Product Change Notification / GBNG-23TQLF033

CCB 5325 Final Notice: Qualification of MMT as an additional assembly site for MIC74YQS and MIC74YQS-TR catalog part numbers (CPN) available in 16L QSOP package.

CCB 5325
Pre and Post Change Summary
PCN #: GBNG-23TQLF033

ANAP

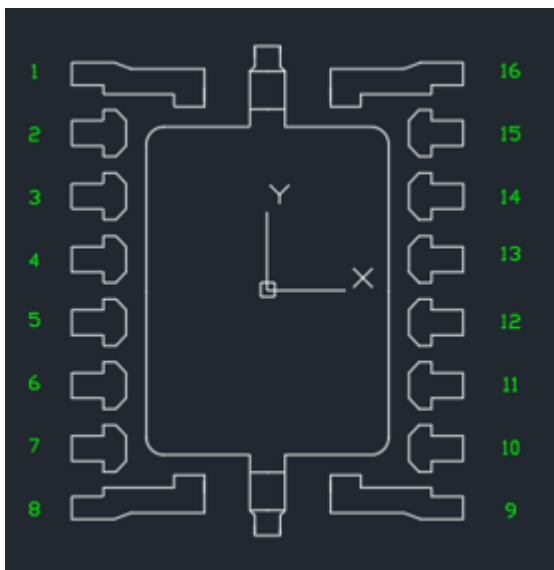
Lead frame material	C194
Lead Frame Paddle Size	96x130 mils
Lead Frame DAP Surface Prep	Rc Ring Ag

MMT

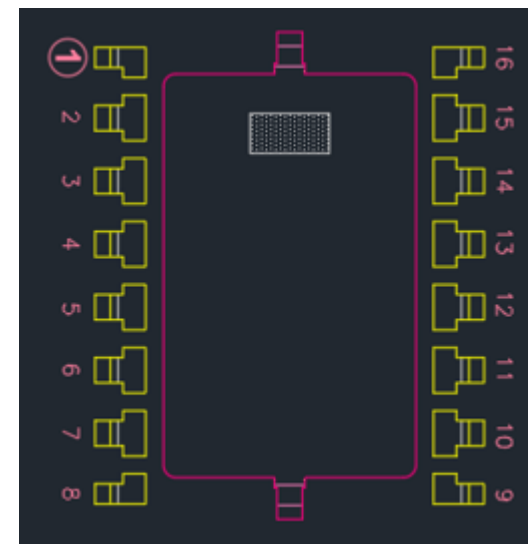
Lead frame material	A194
Lead Frame Paddle Size	100x160 mils
Lead Frame DAP Surface Prep	Ag-RT
